Addendum No. 01

Subject: John Taggart ES – Classroom Modernization

SDP Contract Nos. B-047C, B-050C, of 2017/18

This Addendum, dated 9th of May, 2018, shall modify and become part of the Contract Documents for the work of this project. Any items not mentioned herein, or affected by, shall be performed strictly in accordance with the original documents.

DRAWING E112 - THIRD LEVEL - LIGHTING FLOOR PLAN - NEW WORK

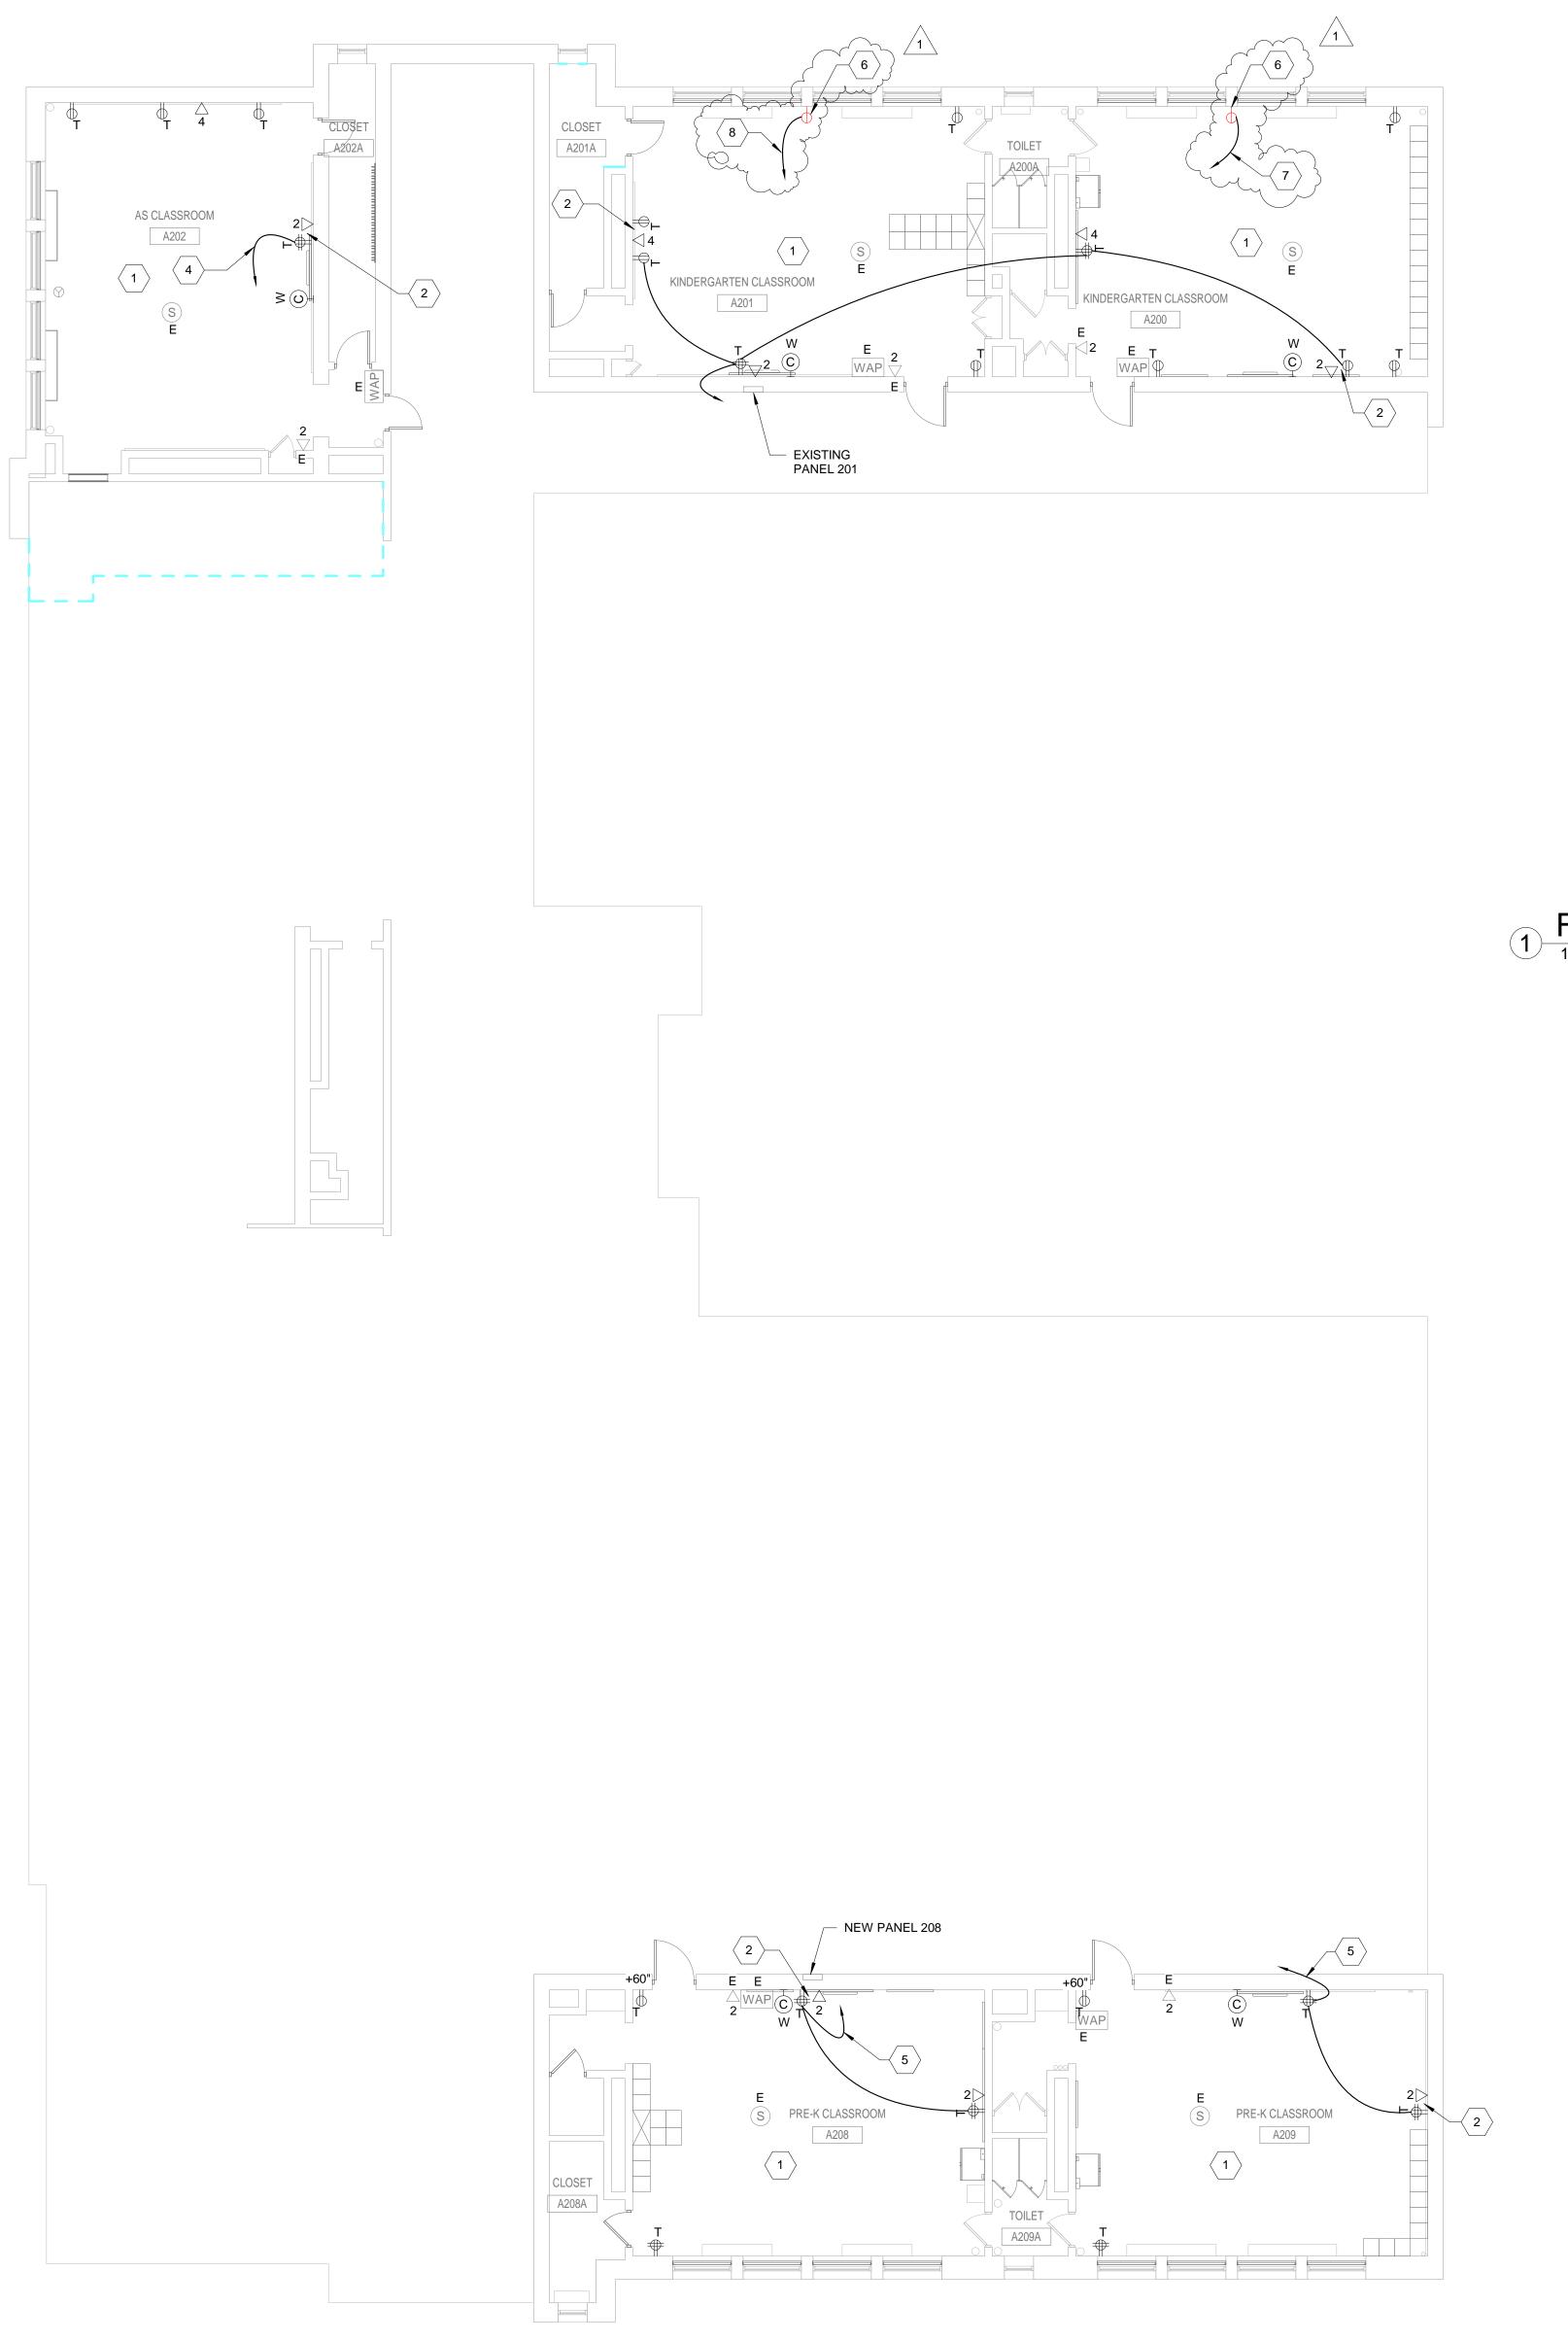
- 1. ADD new lights in toilet and storage.
- 2. ADD MDF room 305.

DRAWING E121 - FIRST & SECOND LEVEL - POWER FLOOR PLANS - NEW WORK

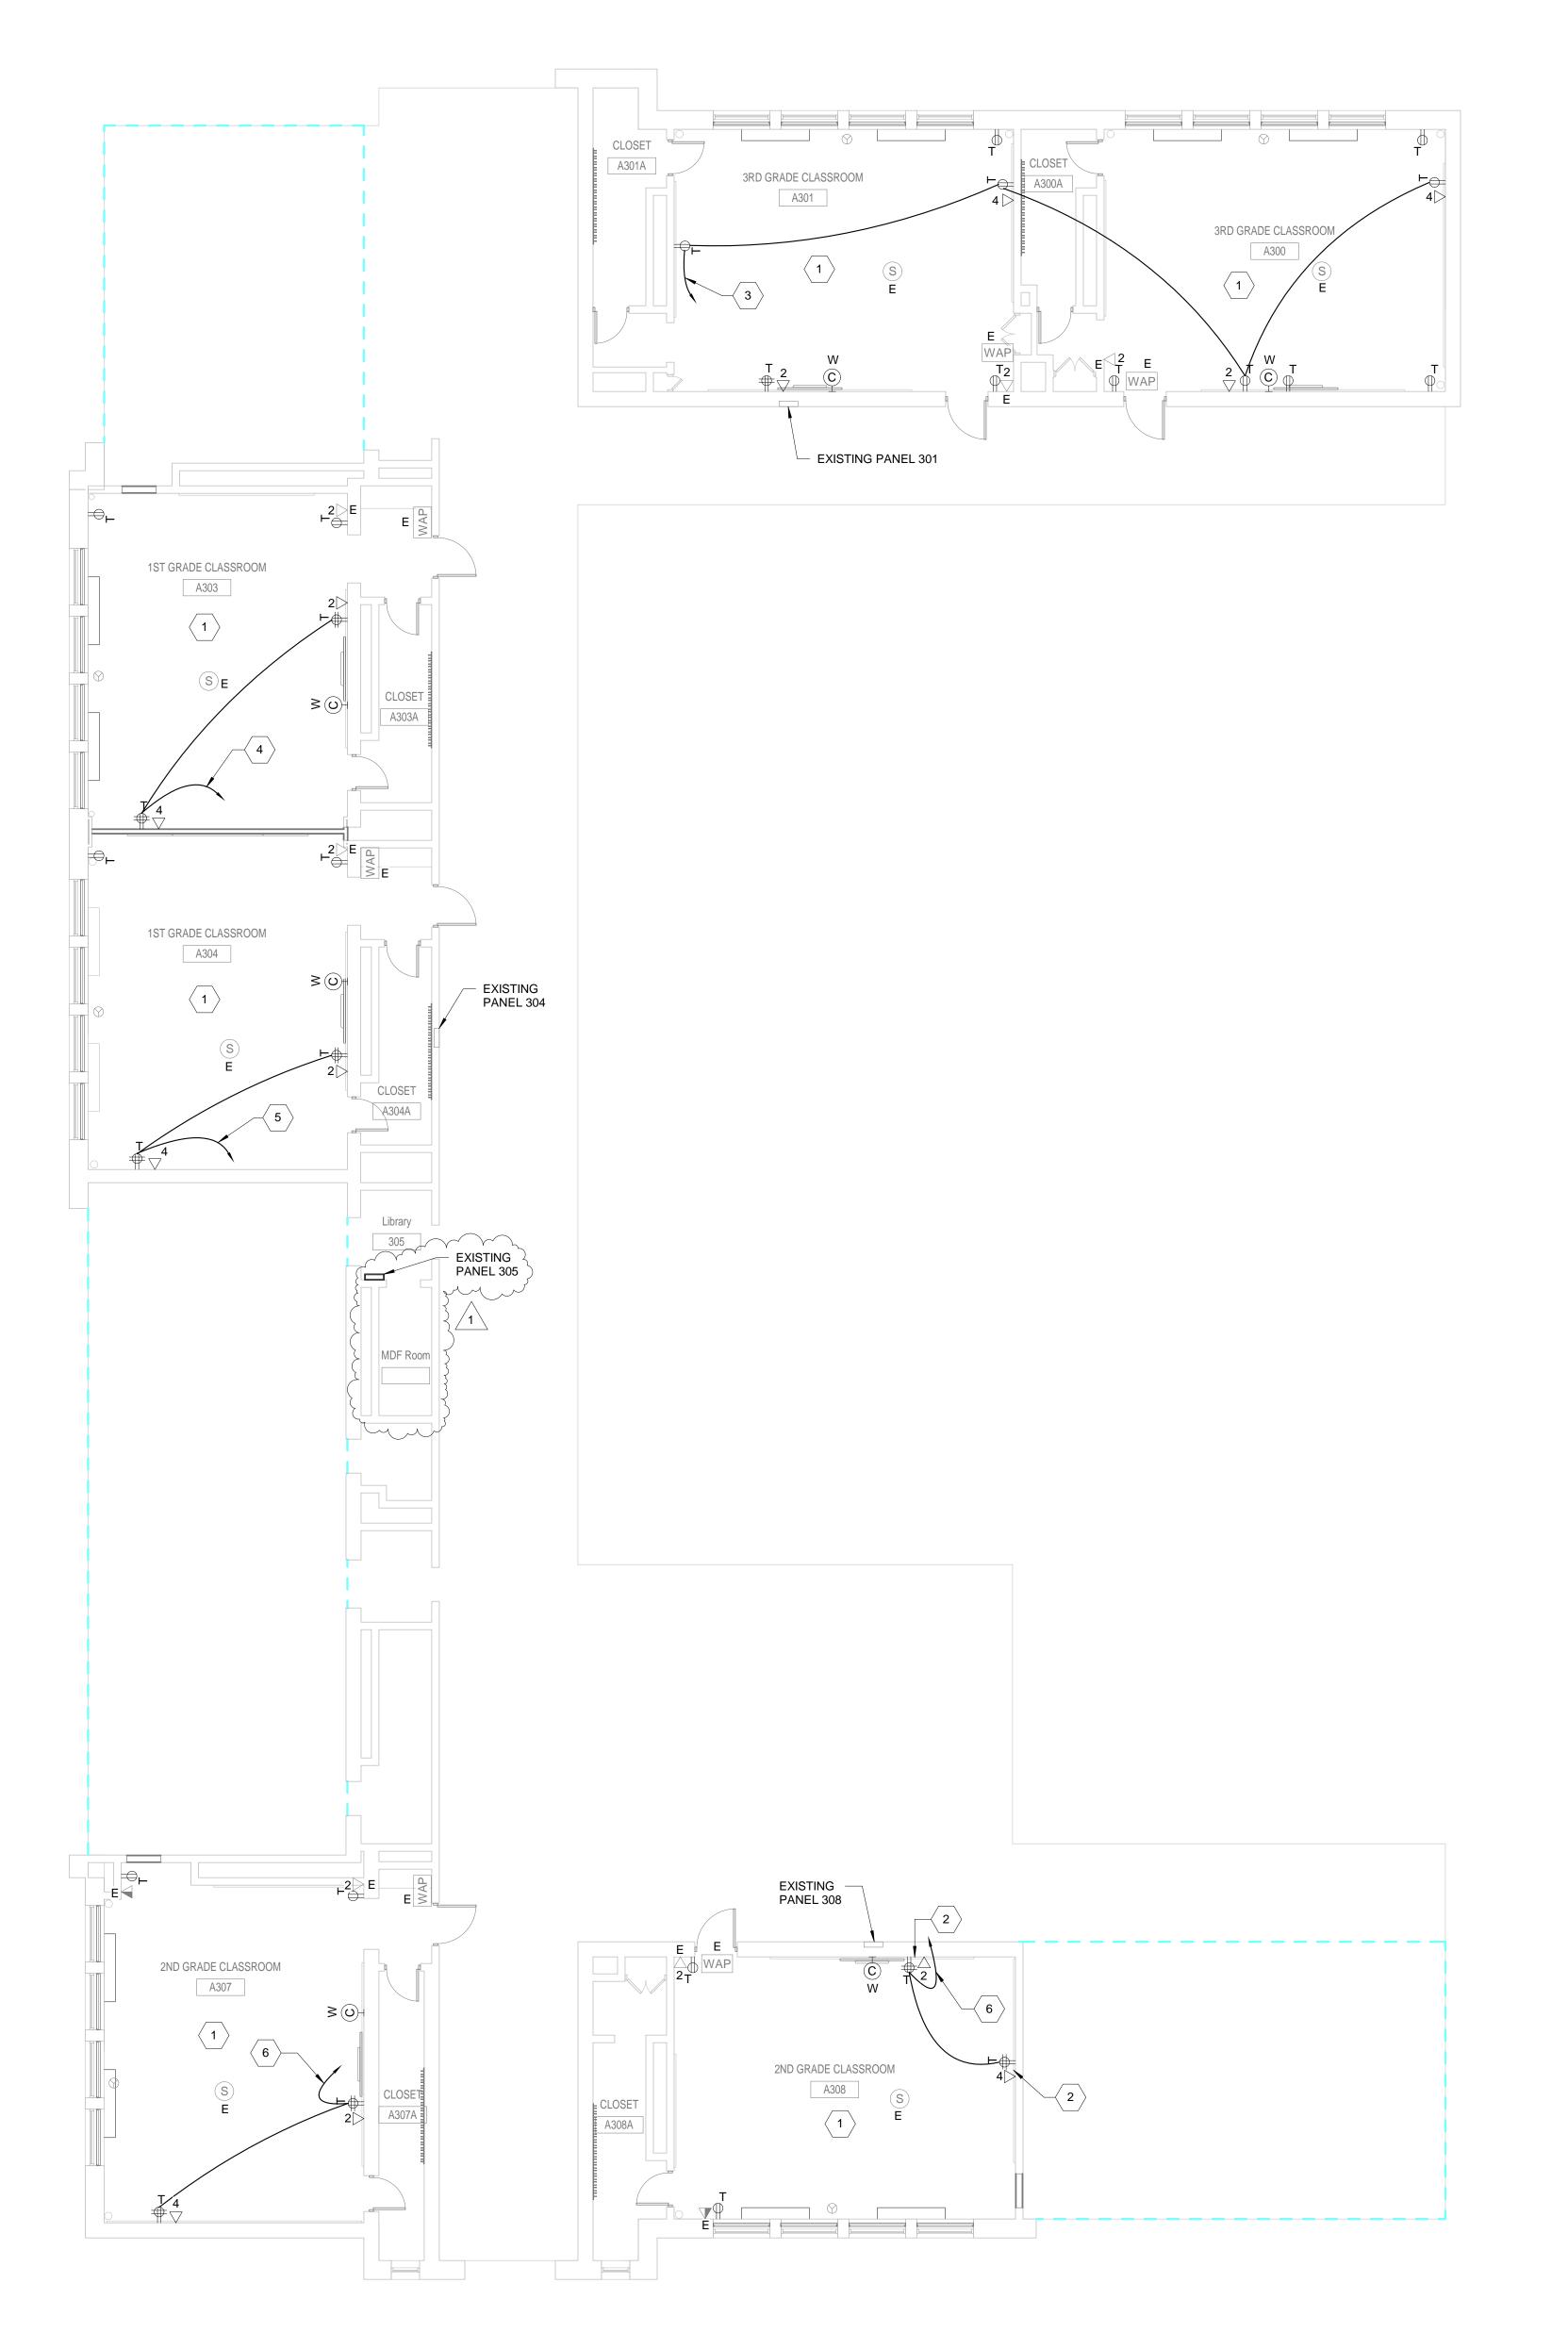
1. ADD receptacles for window AC unit and key notes.

DRAWING E122 - THIRD LEVEL - POWER FLOOR PLAN - NEW WORK

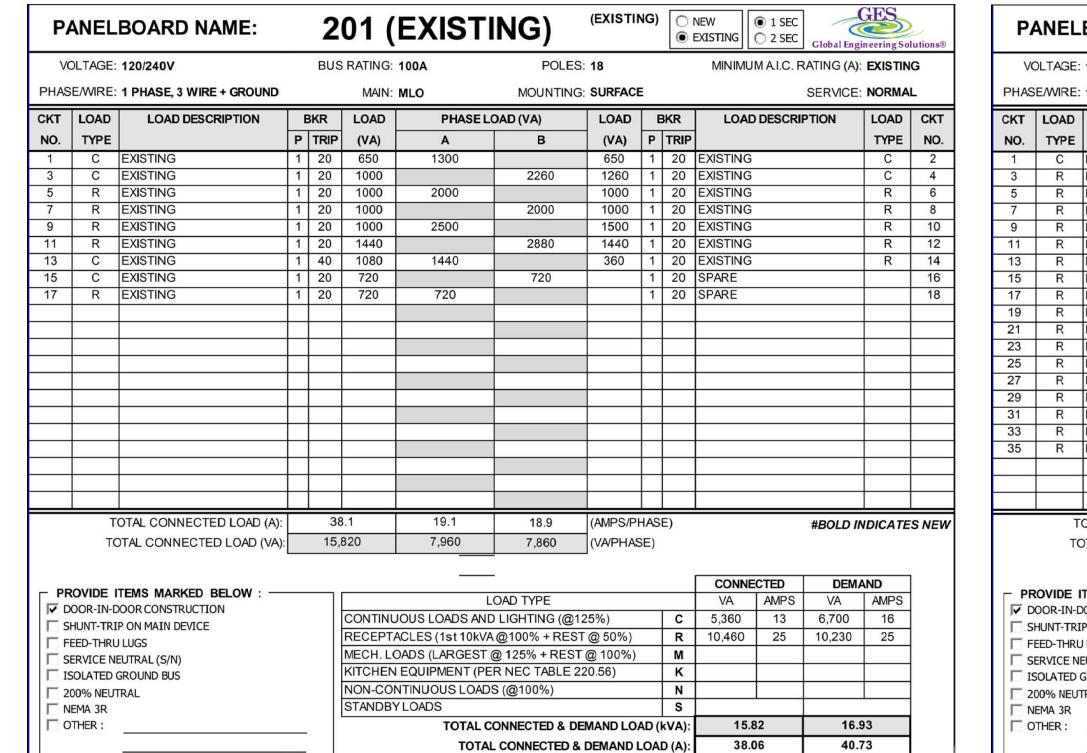
1. **ADD** MDF room 305.

DRAWING E401 - ELECTRICAL PANELBOARD SCHEDULES

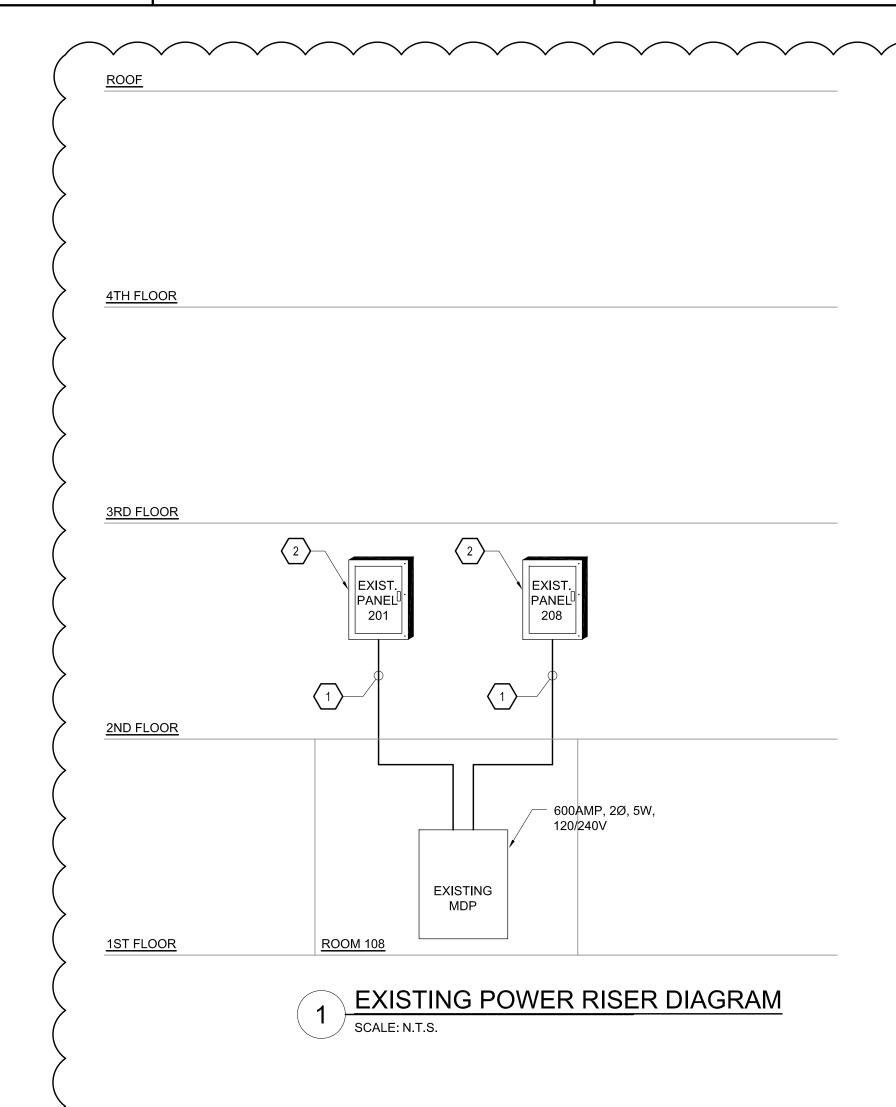
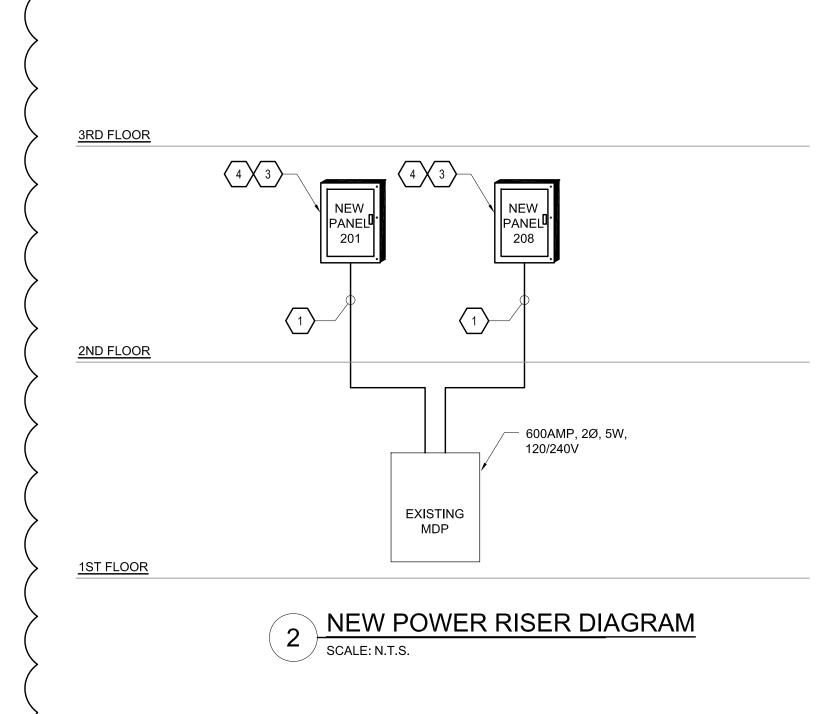
7. Question: Please confirm panelboard 208 is being replaced in kind and feeder is being reutilized.

- 1. ADD Panelboard schedules 201 existing and new.
- 2. ADD Power riser diagrams existing and new.

<u>Response:</u> Yes, Panelboard 208 is being replaced in kind with additional circuit breakers as indicated on contract drawings and existing main feeder is being utilized.
